M L BOURKE, HENMAR TRUST - ADDITIONAL COMMENTS FOLLOWING HEARING

1.0 PROPOSED BARDOWIE STRUCTURE PLAN – CHANGES TO HENMAR TRUST VEHICULAR AND SERVICE ACCESS AGREED AS PART OF PC11

Figure 1: Section 42A Report – Appendix 2 Track Changes to District Plan – Bardowie Industrial Precinct

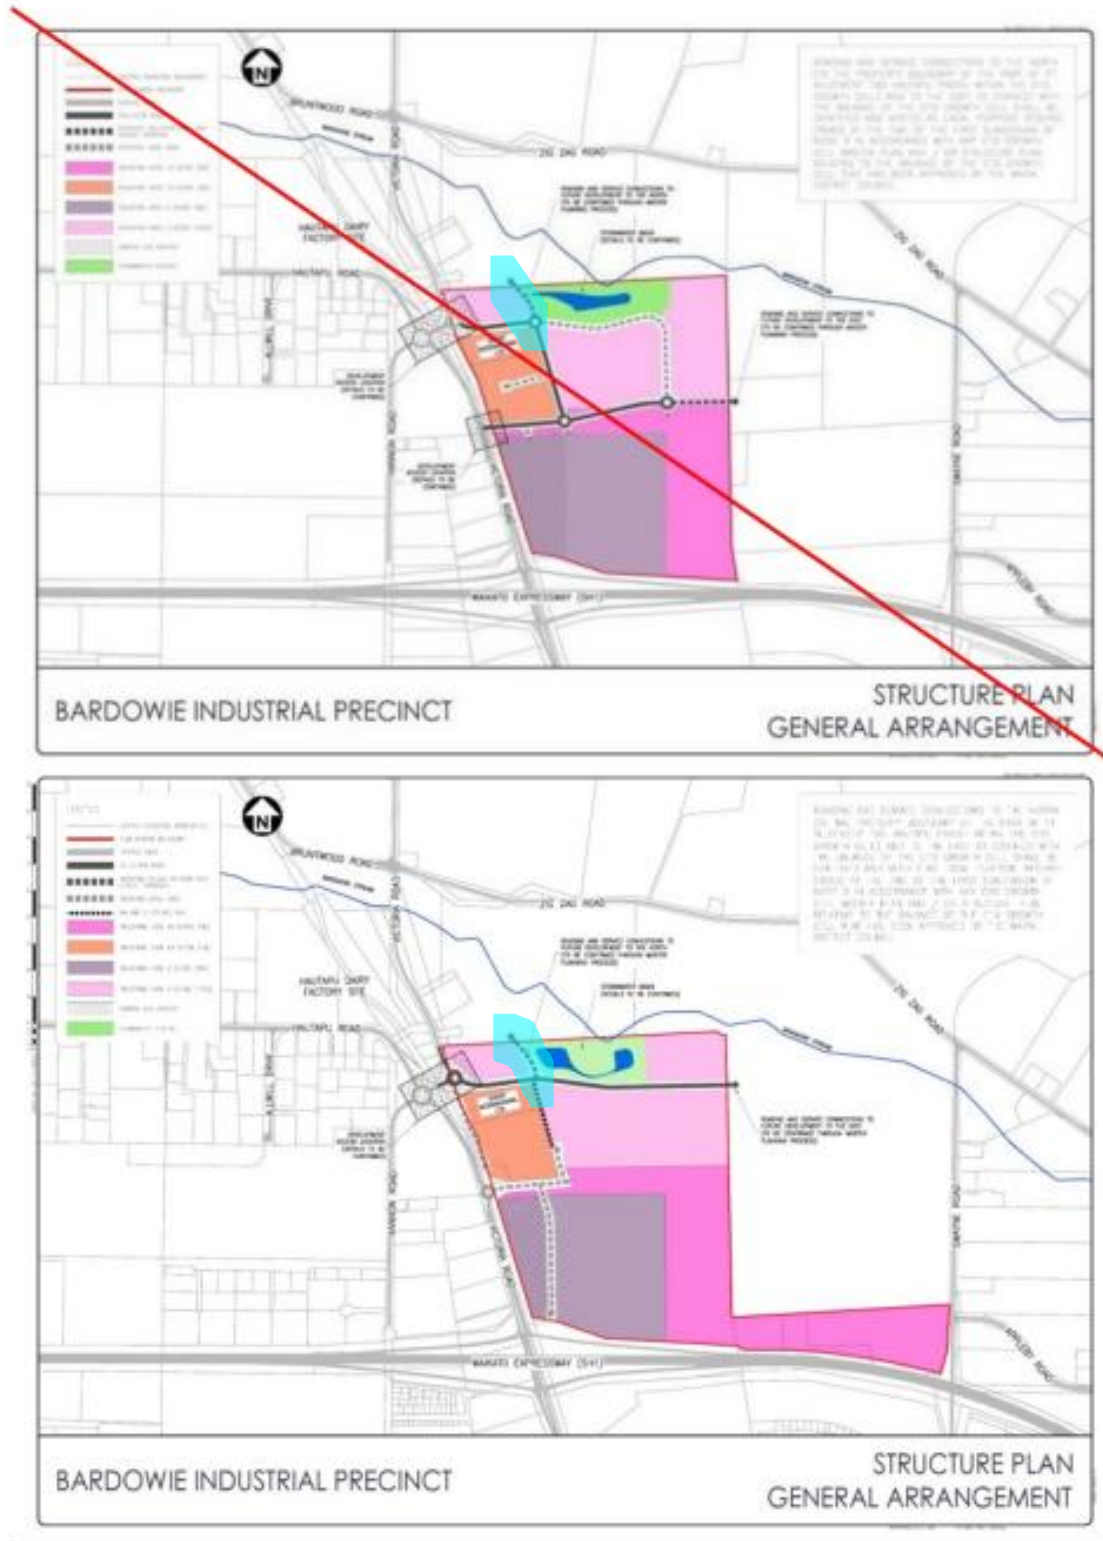
- 1.2 At the Hearing when asked by the Hearing Panel whether there were any changes to the access to the Henmar Trust property on the Bardowie Structure Plan, Fonterra experts advised that there was no change. This is incorrect as illustrated in the plans from Appendix 2 – Track Changes to the District Plan attached to the Section 42A Report.

- 1.3 The changes to the Henmar Trust access have been highlighted in blue and clearly illustrate the agreed round-a-bout being removed.
- 1.4 The wording on the Structure Plans is not legible and it is requested that the plans be updated to include legible text so that it is clear what changes are proposed to the existing Structure Plan text.

- 1.5 As illustrated on the proposed Bardowie Industrial Structure Plan the agreed round-a-bout is still located on a four-lane intersection.

Figure 2: Section 42A Report – Appendix 2 Track Changes to District Plan – Mangaone Industrial Precinct

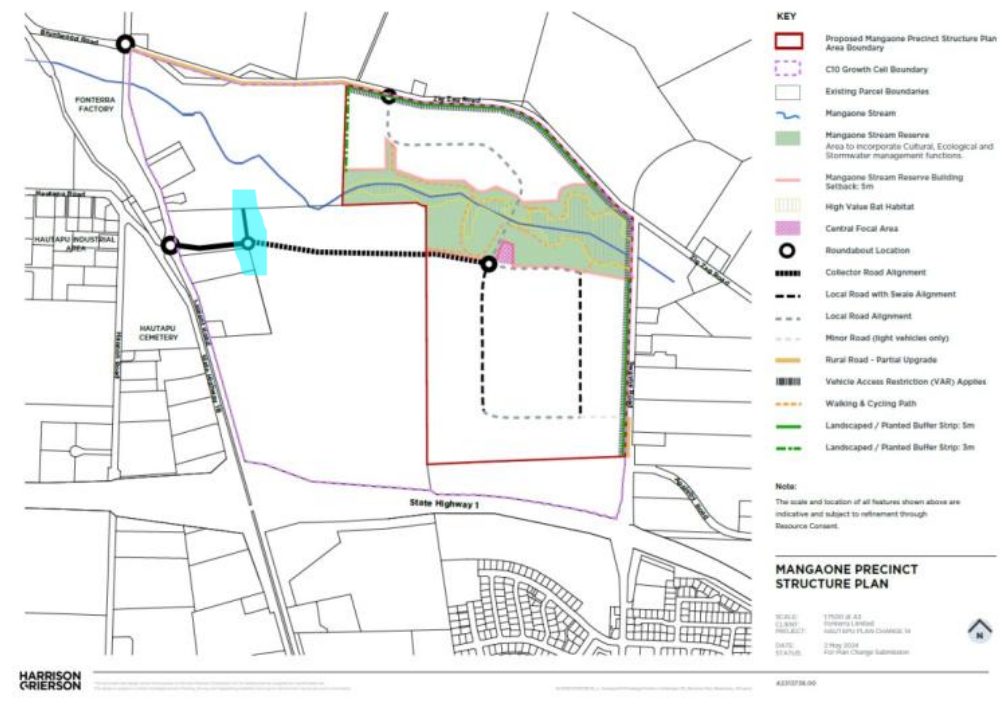
- 2.1 Additionally, Fonterra through their expert evidence have sought the removal of the agreed round-a-bout to the Henmar Trust property from the Bardowie Industrial Precinct. Please refer to the plans on the following page. Alteration highlighted in blue.

Figure 4: Updated Mangaone Precinct Structure Plan Providing Connectivity to C10

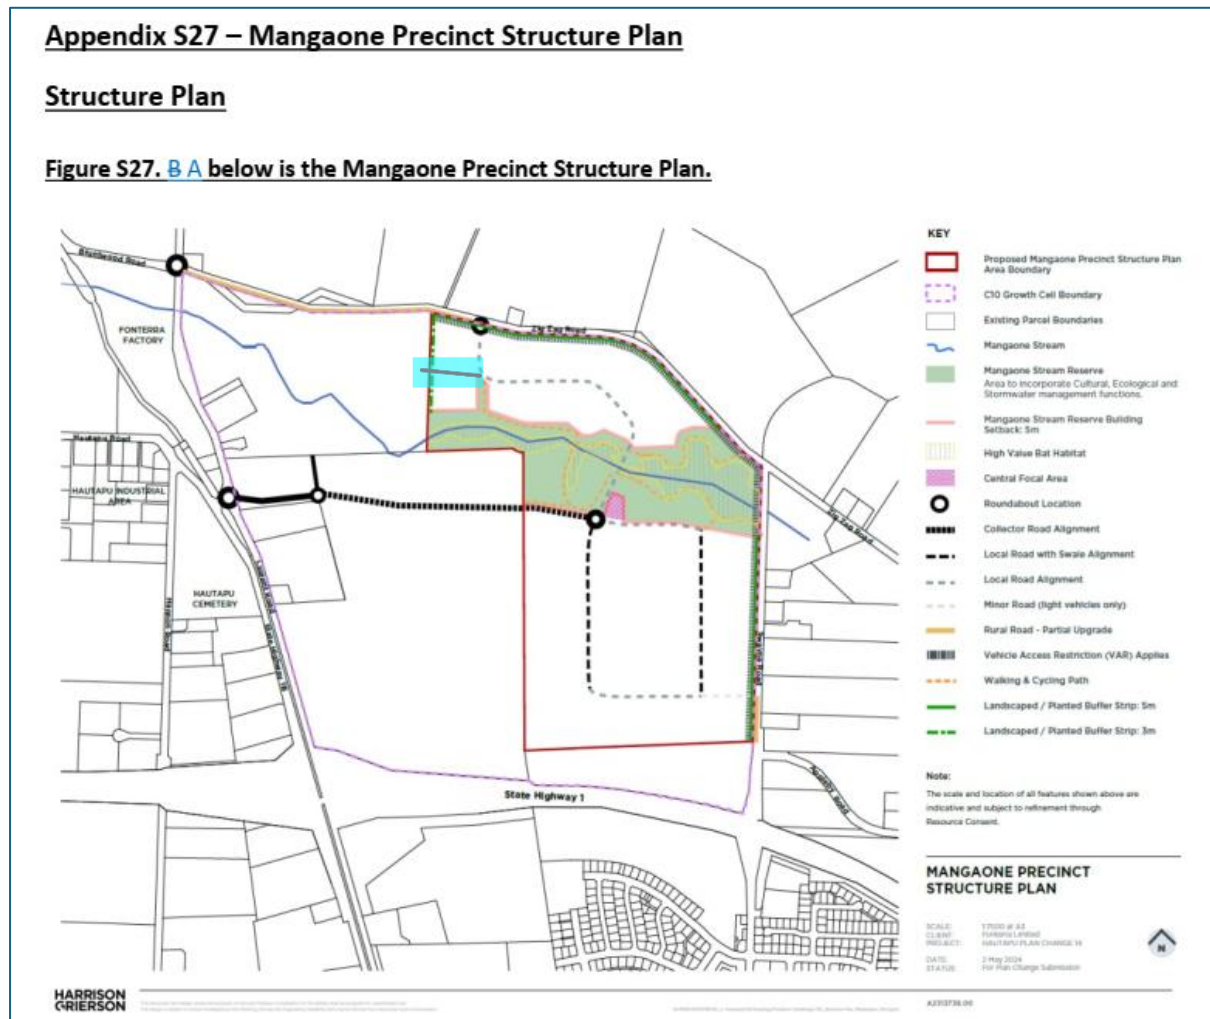
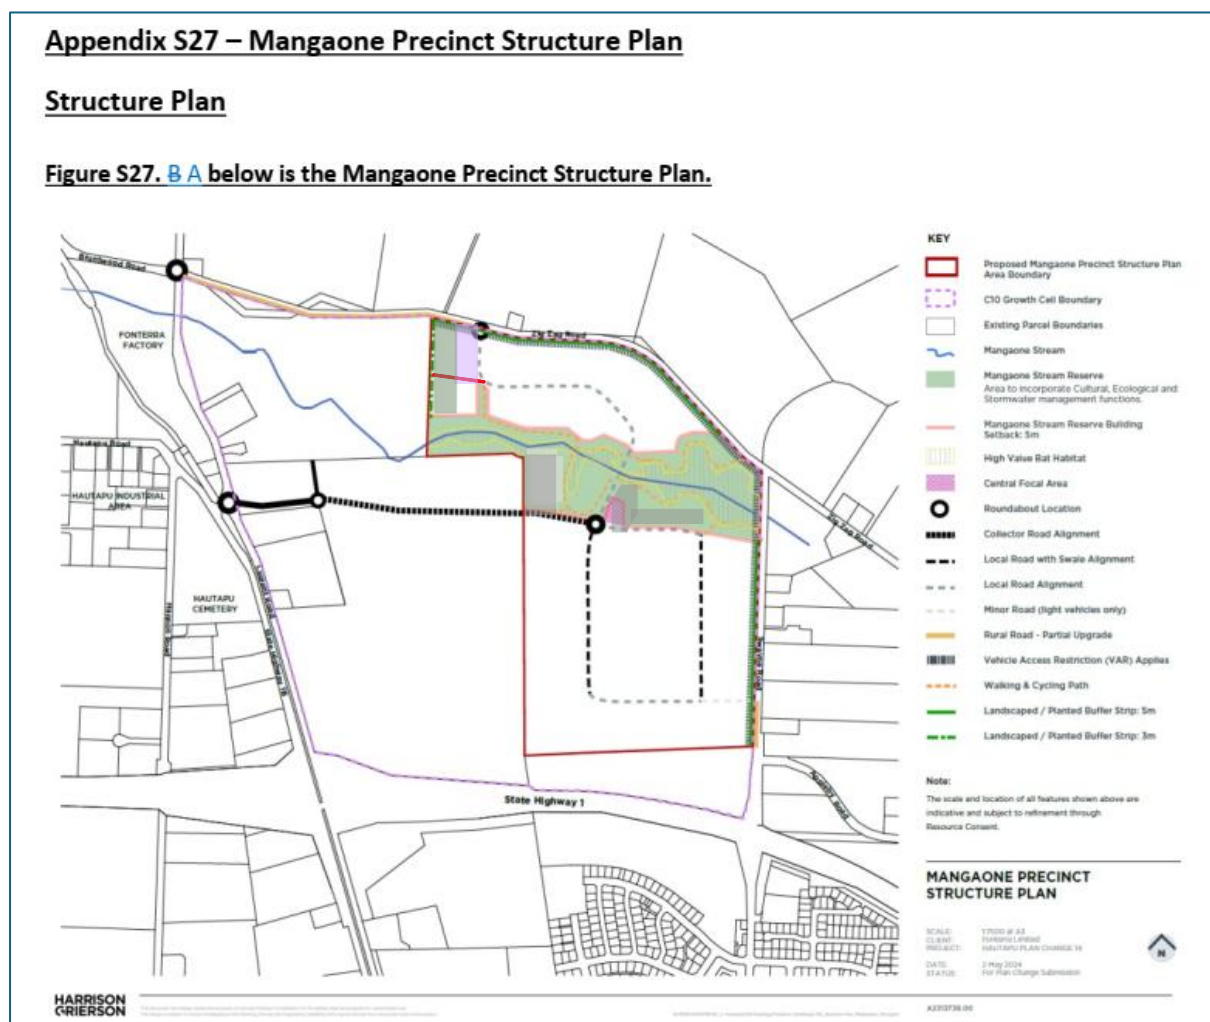
- 3.1 Propose that the Mangaone Structure Plan be amended to include vehicular and service connectivity to the Henmar Trust property as outlined in the diagram below and highlighted blue;
